Memorandum

Date: April 23, 2024
To: Dago Garcia, P.E., City Engineer
Cc: Curtis Stultz, Public Works Director
Cole Grube, P.E., Project Engineer
Chris Kerr, Community Development Director
Bryan AnDyke, Land Development Project Manager, Lennar Northwest, LLC
Zeb Buswell, Canby Excavating
From: Colin Cortes, AICP, CNU-A, Senior Planner *cc.*
Subject: **Smith Creek Development Phase 4A Apr. 19 second inspection follow-up (FSUB 22-01)**

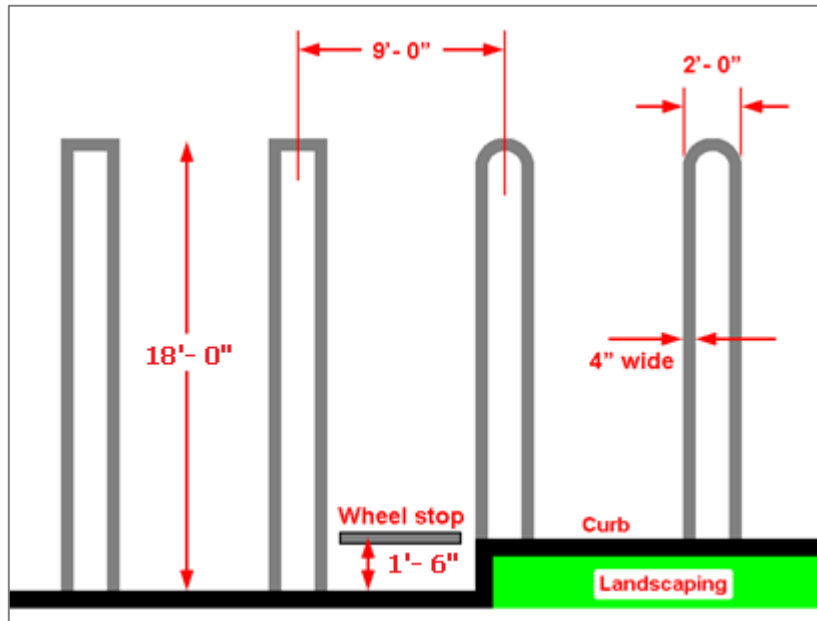
The photo below goes with the Sheet L3.0 comment about the west bicycle parking:

- 4. Drainage: Positive drainage is lacking along the north side of the trail a little east of the north-south segment. Correct to preclude pooling of water and in a way that the Public Works Department Engineering Division accepts.*

The developer is to resolve.

SHEET
 L2.0
 OF
 6

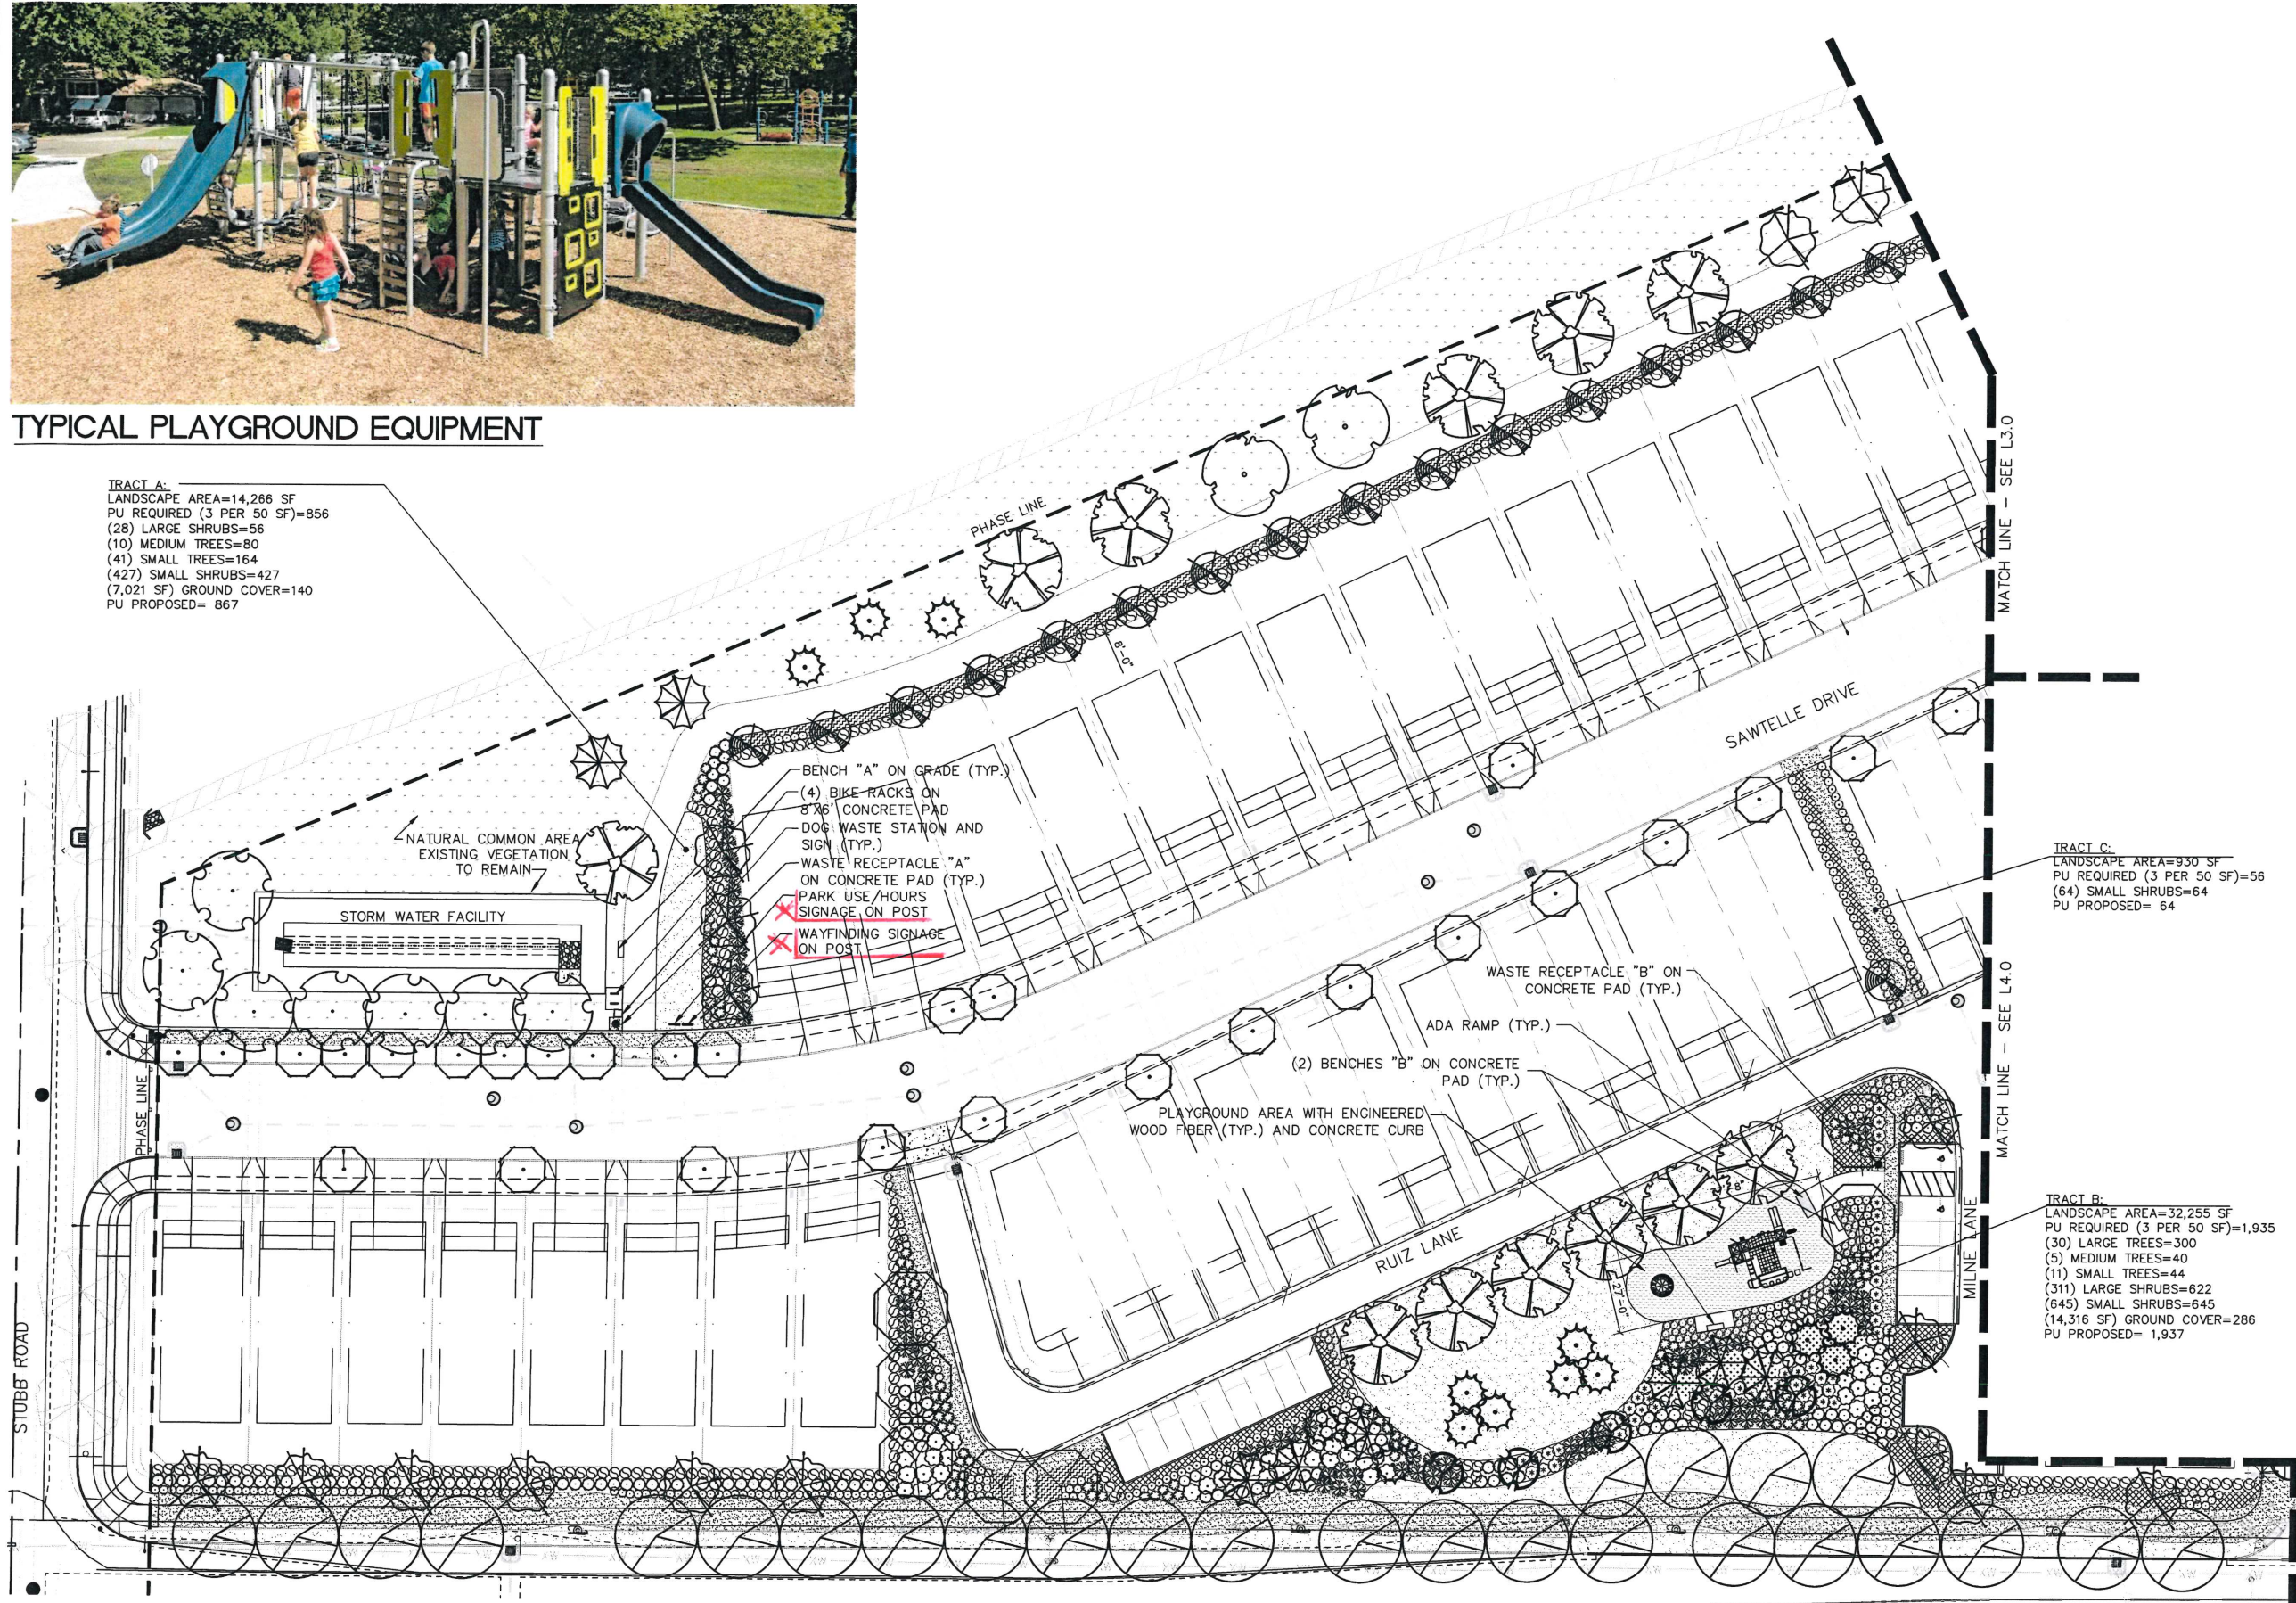
a. Sheet L2.0: All the symbolized and called out greenway trail amenities and support facilities are missing: bench, 2 bicycle U-racks on 8 x 6-ft concrete pad, dog waste station with sign, trash receptacle, park use/hours sign, and wayfinding pole sign. Refer to Sheet L5.0 for specs.

What remains missing are per the attached landscape Sheets L2.0 & L3.0 marked with red comments.

SHEET
L3.0
 OF
6

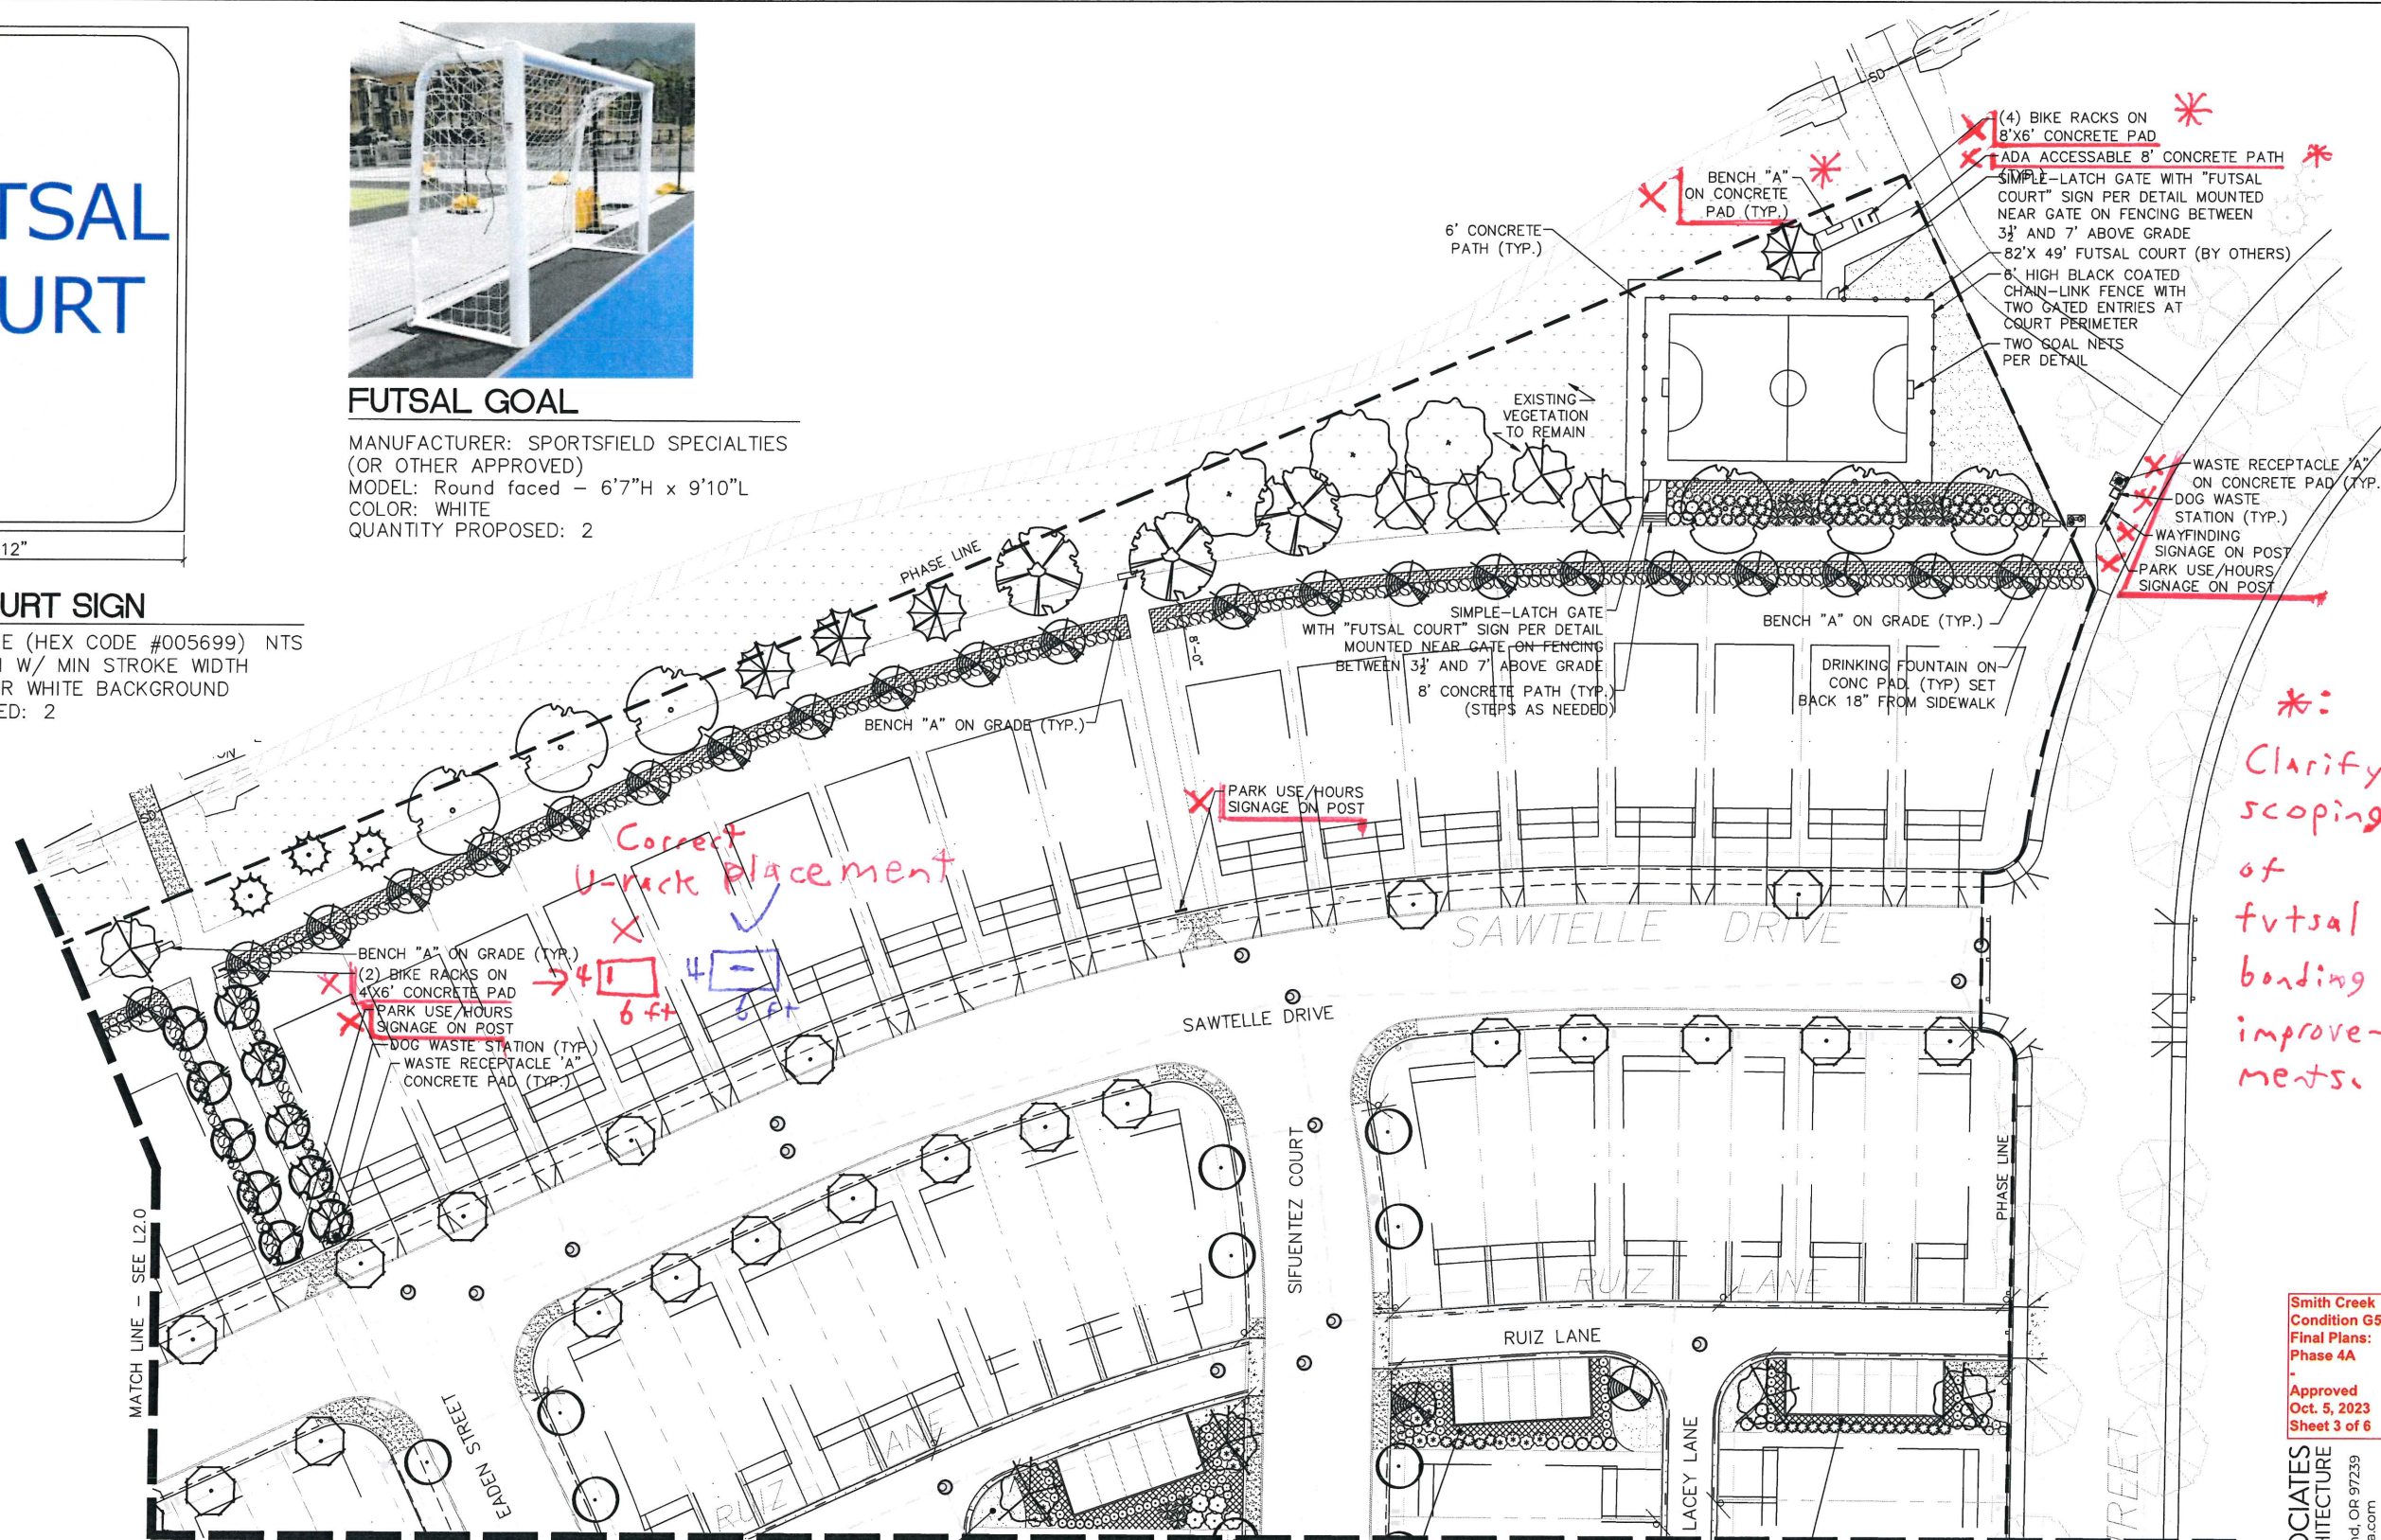
*:
Clarify
scoping
of
futsal
bonding
improvements.
